RENESAS TECHNICAL UPDATE

Product Category	MPU & MCU	Document No.	TN-16C-A195A/E	Rev.	1.00
Title	Errata to R32C/153 Group Hardware Manual	Information Category	Technical Notification		
Applicable Product	R32C/153 Group	Lot No.	Reference Document	R32C/153 Group Hardware Manual Rev. 1.03 (REJ09B0505-0103)

This document describes corrections to the R32C/153 Group Hardware Manual, Rev. 1.03.
The corrections are indicated in red in the list below.

Figure 24.32 LINi_j Interrupt Block Diagram (i = 0, 1; j = 0 to 3)

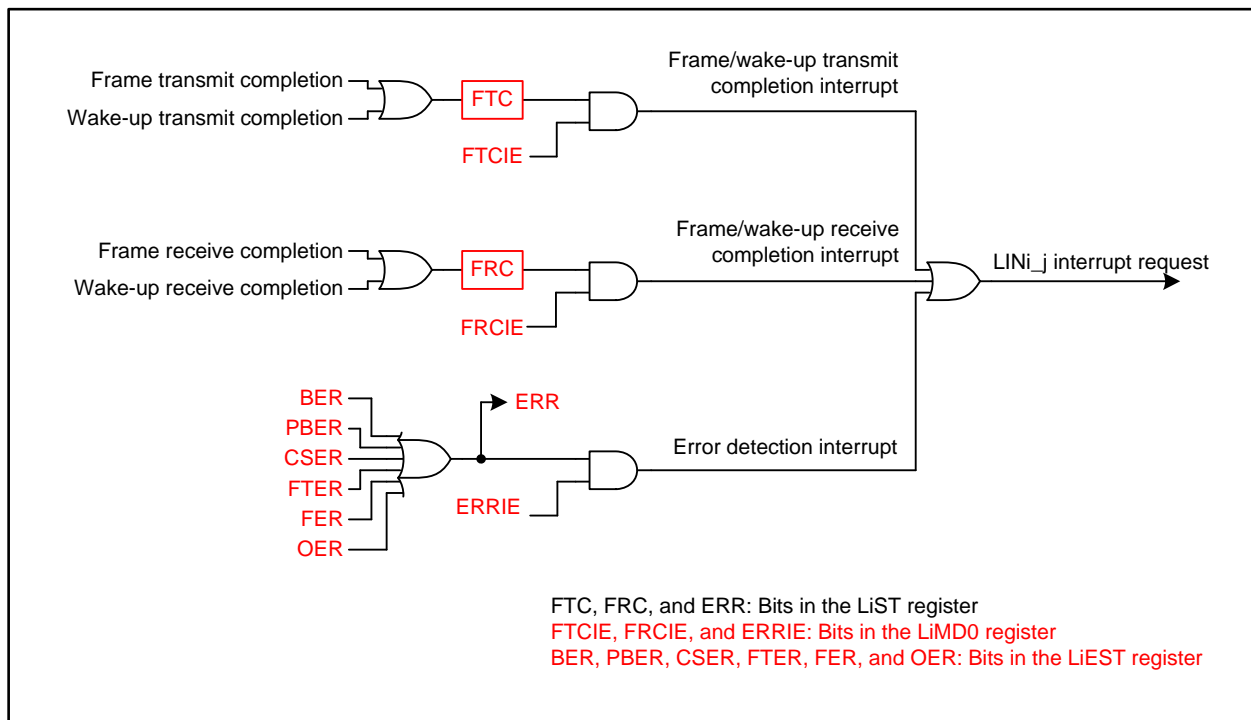
- Page 448 of 653, description for Detecting Condition for Input signal low detection in Table 24.8 is changed as follows:
 “When the falling edge of input signal at the LINi_jIN pin is detected with the setting of the LDE bit in the LiMD0 register to 1 (Input signal low detection enabled), or when setting the LDE bit to 1 while the LINi_jIN pin is low.”
- Page 449 of 653, value range “; j = 0 to 3” in the title of Table 24.9 is deleted.
- Page 451 of 653, description in lines 9 to 10 of 24.11 is added as follows:
 “The respective interrupt request is output when the corresponding flag in the LiST register becomes 1 while the corresponding bit in the LiMD0 register is set to 1 (interrupt enabled). No new interrupt request is generated by the other sources if any of them is 1 since multiple interrupt sources are aggregated.”
- Page 451 of 653, Figure 24.32 is corrected as follows:

Figure 24.33 LINi Low Detection Interrupt Block Diagram (i = 0, 1)

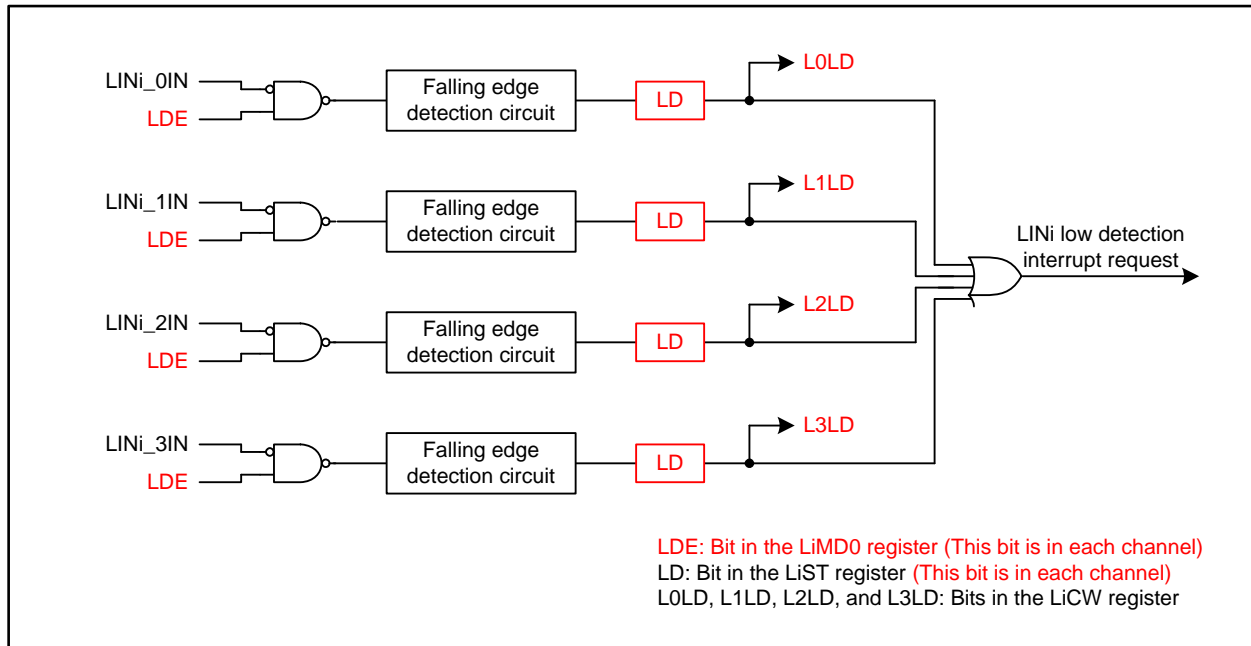
•Page 452 of 653, Figure 24.33 is corrected as follows:

Figure 27.2 Addresses for ID Code Stored

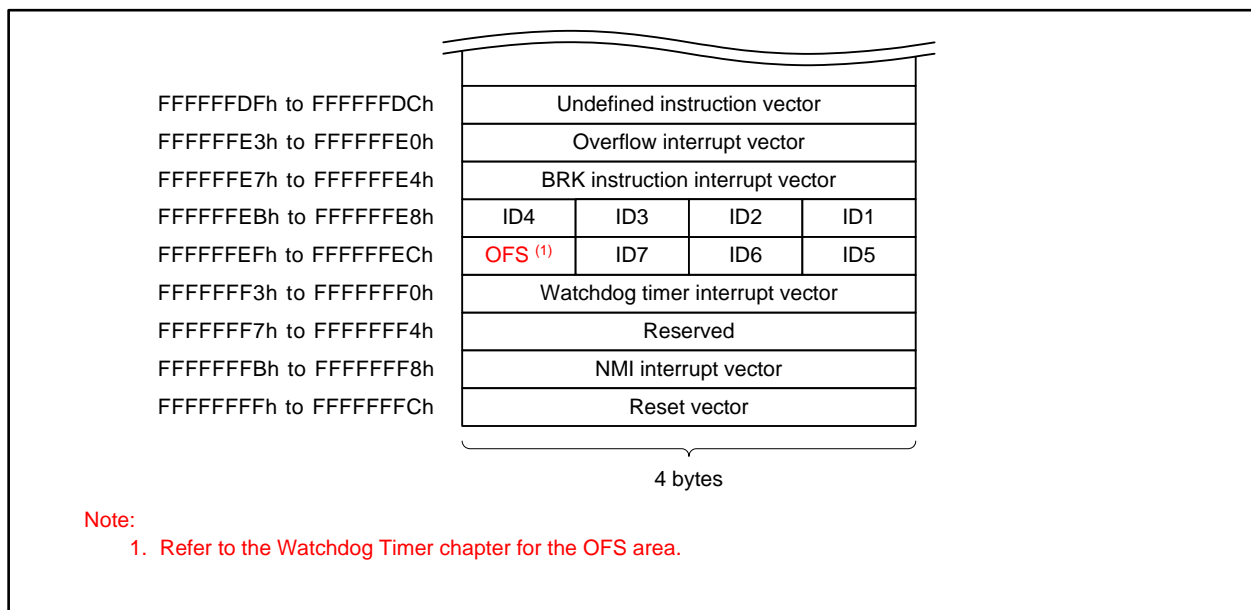
•Page 557 of 653, Figure 27.2 is corrected as follows:

Figure 27.13 Read Timing

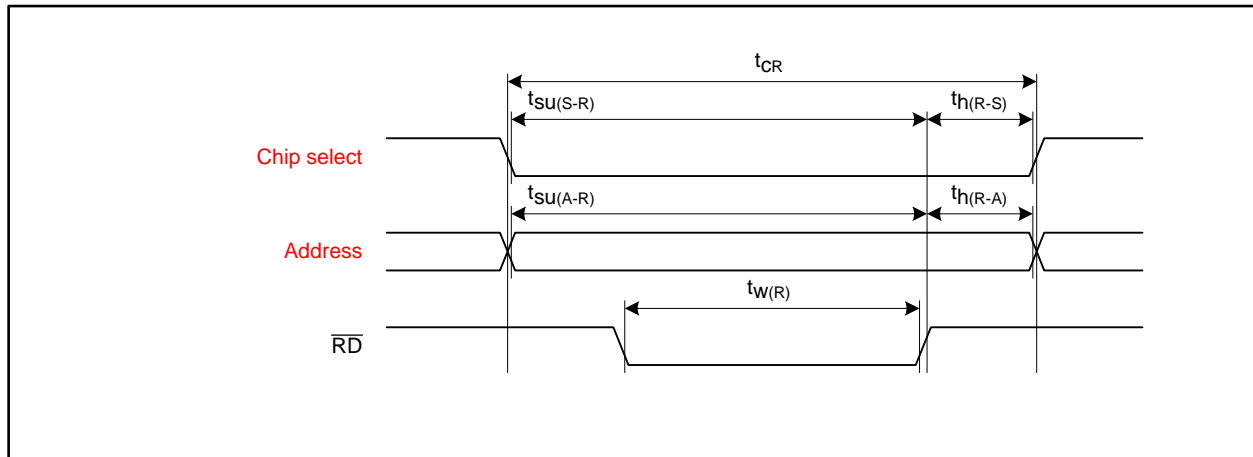
- Pages 566 and 568 of 653, descriptions in Figures 27.13 and 27.14 are corrected as follows:

Figure 29.5 Flash Memory CPU Rewrite Mode Timing

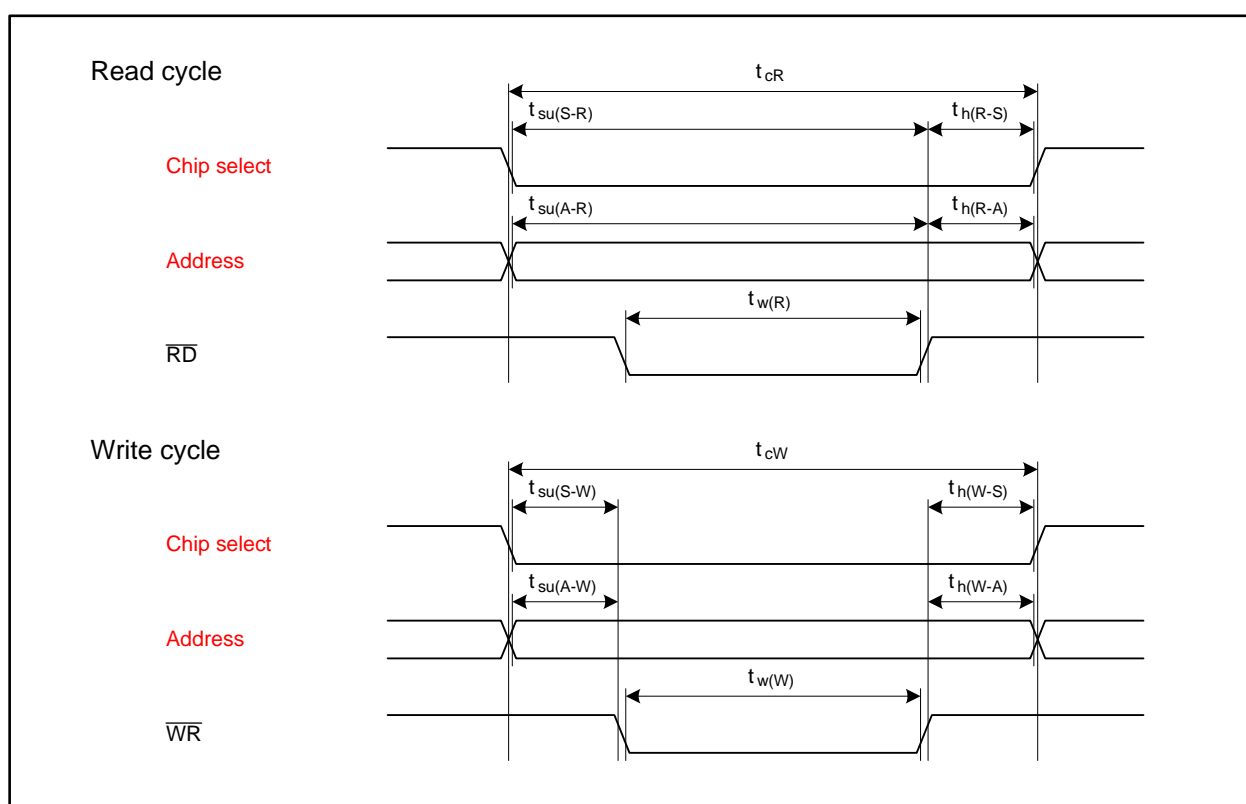
•Page 605 of 653, descriptions in Figure 29.5 are corrected as follows:
